4054 HARDCOPY ON POWER-UP MOD #40915

4054 OPTION 30 MOD #M40364

Figure 1 Schematic 8-1 of 4054 Service Manual
Display Controller 670-5672-02

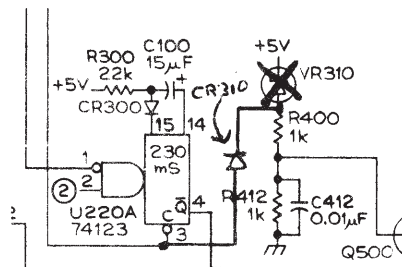
The 4054 will initiate a Hardcopy on "Power Up" if a Hardcopy unit is connected and turned on. MOD #M40915 addresses this problem as follows.

1. Remove zener diode VR310 (152-0278-00).
2. Add the new diode CR310 (152-0061-00, anode to pin 3 of U220 and the cathode to the spot where the anode of VR310 use to be soldered.
